**SERVICE ACTION: REWORK ROOF-MOUNTED AERIAL**

F90 M5	G12 7 Series	G30 5 Series
--------	--------------	--------------

This Service Action involves 5 Series, 7 Series and M5 vehicles produced from April 2018 through May 2018.

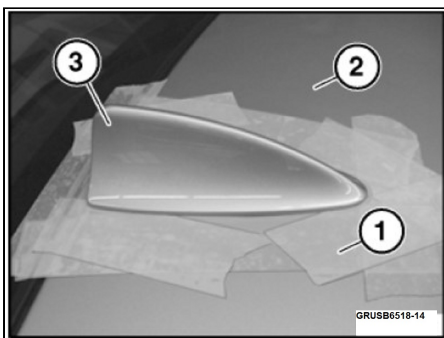
A gap in the roof-mounted aerial adhesive could cause water to leak into the vehicle interior.

During production the roof-mounted aerial was not sealed correctly.

Reseal the roof-mounted aerial.

### Installing the roof-mounted aerial housing

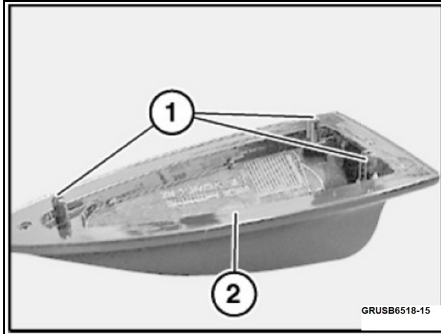
- Check centering pins (1) for damage.

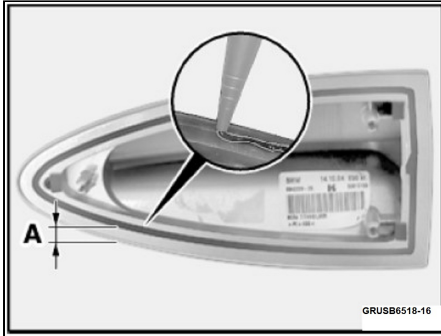
- The bonding surface (2) must be clean and free from grease.

- Apply trace of adhesive bead all around outer contour as follows.
- Distance between adhesive bead and edge of aerial housing:
  - A = 6.5 mm +/- 1 mm
- The start and end of the bead must overlap by a maximum of 10 mm
- To prevent the adhesive from leaking, the adhesive bead diameter must not exceed 2.5 mm to 3.5 mm
- Attach the empty housing coated with adhesive by hand. To spread the adhesive better, move the housing back and forth horizontally slightly when pressing down.
- Secure empty housing if necessary with adhesive tape and press down uniformly.
- After bonding, leaving vehicle to stand for at least 3 hours at room temperature.
